Memorandum

Subject: AP-23-01 Appellant Testimony

Between the City Council Public Hearing on March 13, 2023 and the March 20, 2023 noon deadline to submit comments, staff received additional testimony (attached) from Russell Axelrod, Appellant, for the appeal of an approved Water Resource Area Permit at 19679 Wildwood Drive.

Photo 4

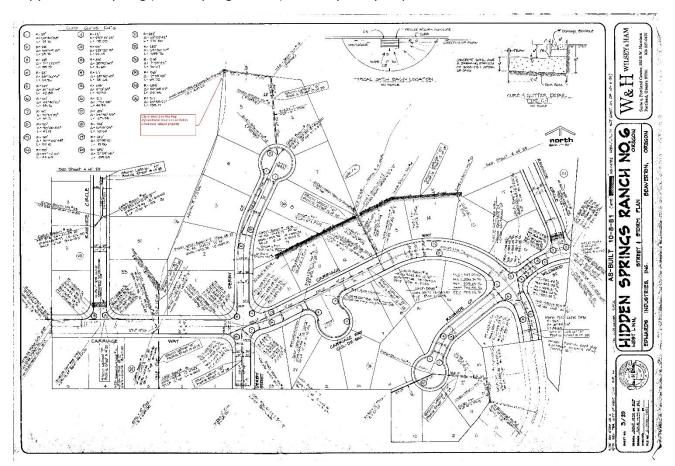
Water flowing in the Robin Creek channel was observed to seep below ground in the area upstream of the riprap impoundment then continues down drainage in the subsurface. At the low flows observed, the creek flow remains below grade underneath the north part of the reach along the subject property, and below the highly disturbed area associated with prior building construction and the City's past and recent storm drain construction projects through this area (Photo's 3 and 4). I could also hear reasonably substantial water flow moving below ground level between the houses in this area next to the City culvert.

Photo's 3 and 4 showing no active surface flow in highly disturbed area from past home construction and City storm drain and culvert construction projects between existing homes on Wildwood Drive. March 16, 2023
